# Cottam Solar Project

### Figure 8.16.2: Landscape and Ecology Mitigation and Enhancement Plan – Cottam 1 North (Sheet 2) Revision A

Document reference: EX1/C6.4.8.16.2\_A

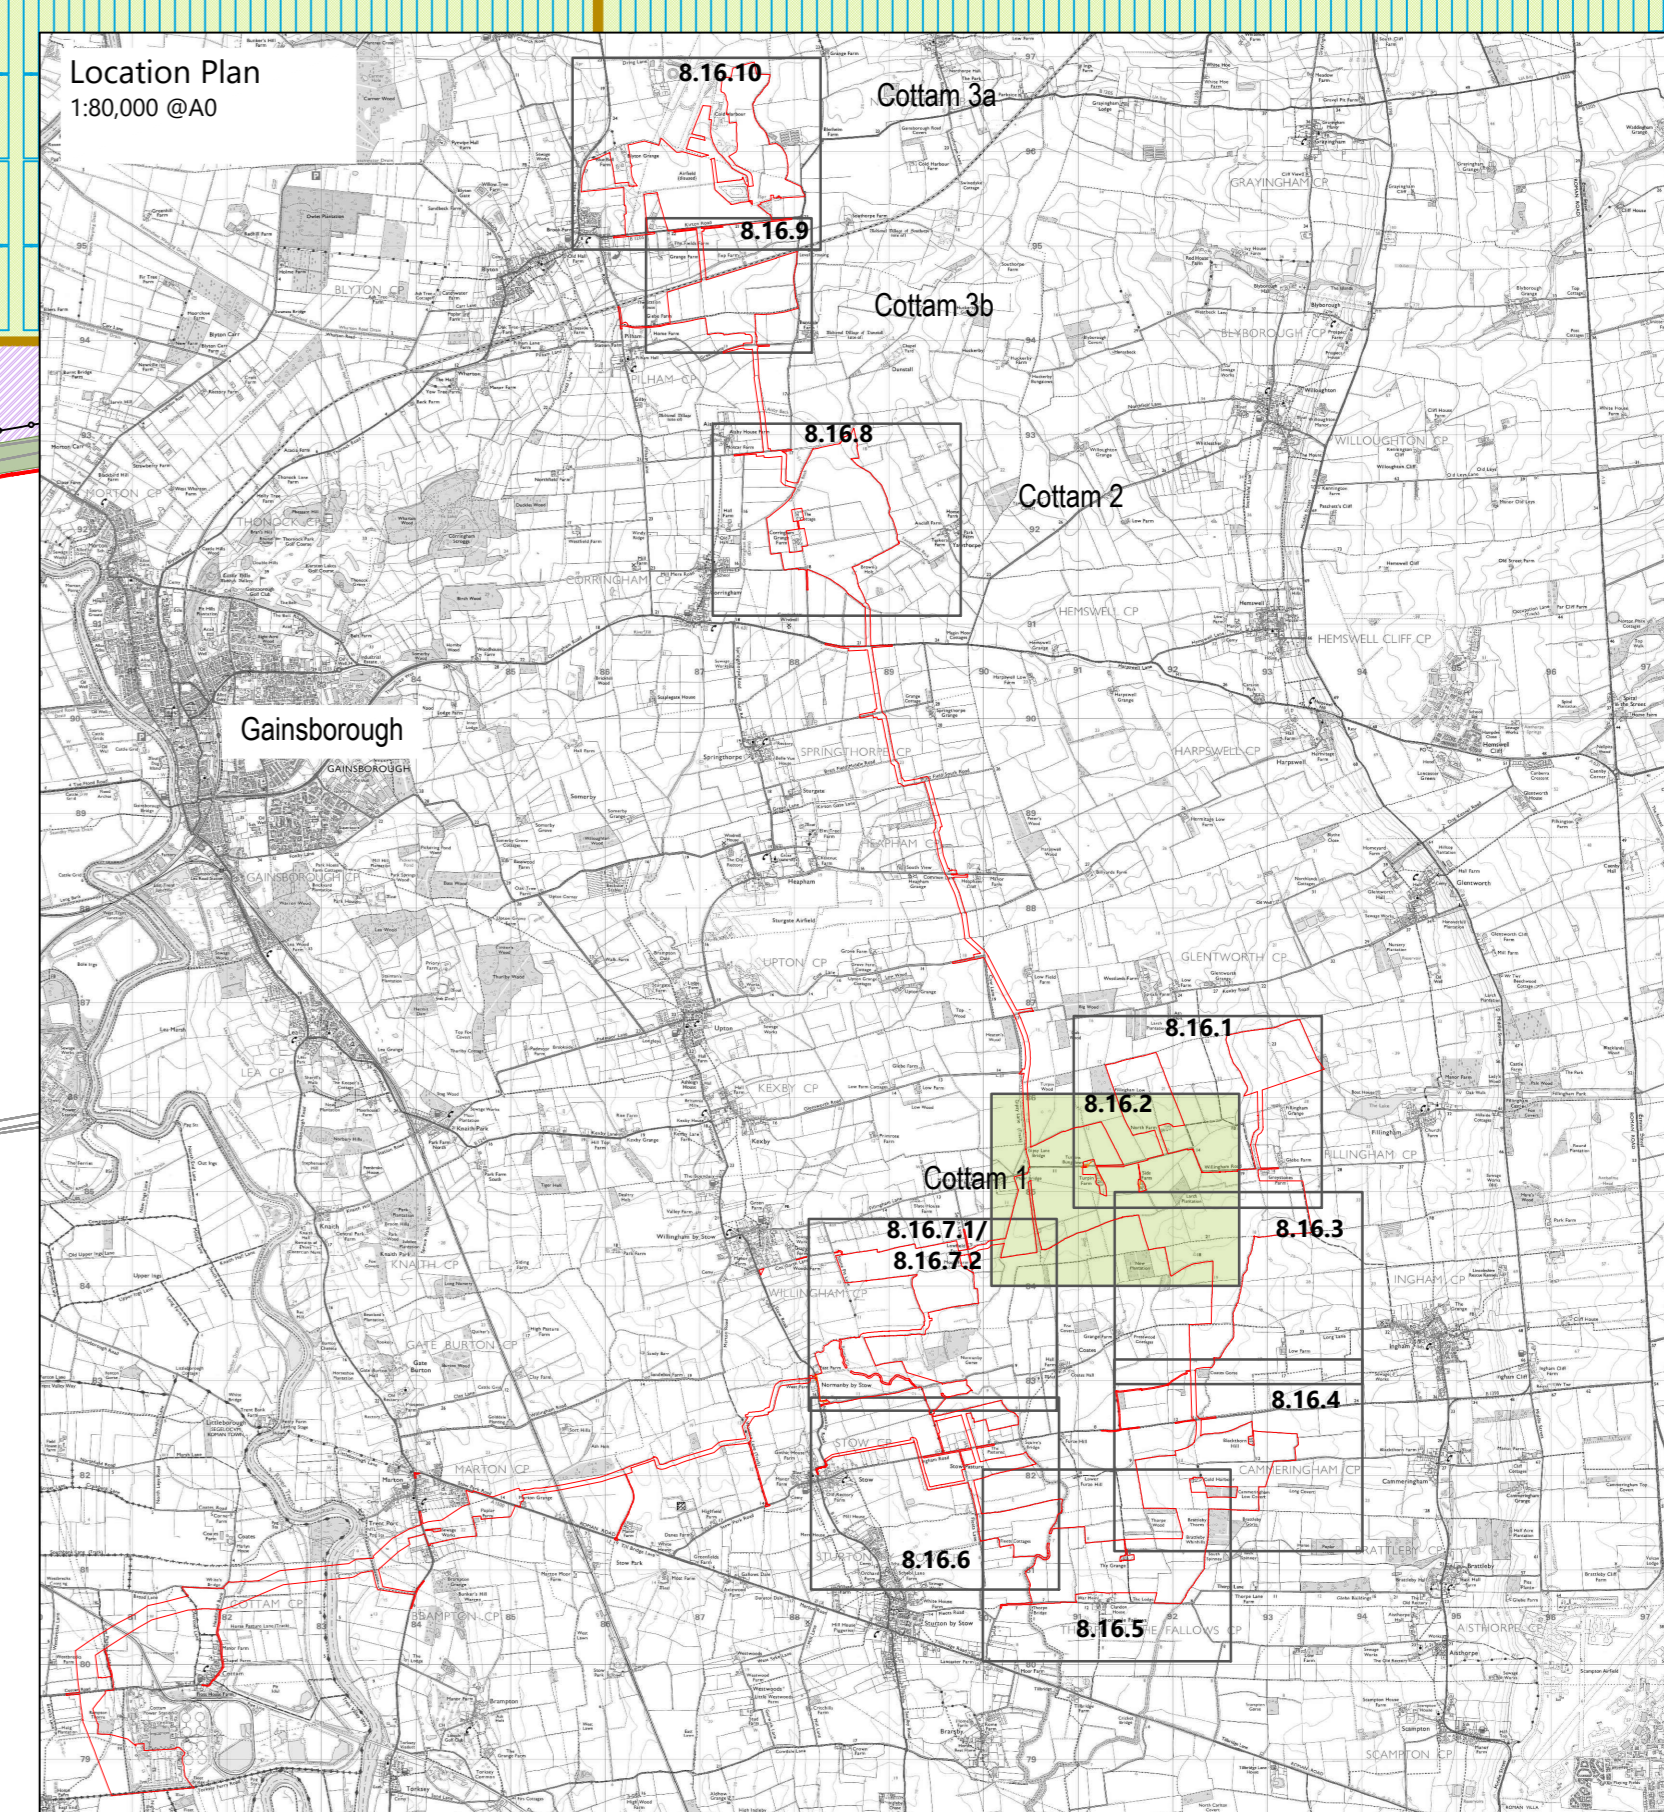
Figure Reference	Page	Description of Changes	Reason for Revision
Figure 8.16.2	3	Change to spelling of 'enhancement'. Offset calculations from drains. Additional Hedgerows to be removed.	For clarity and consistency. To correct a typo.
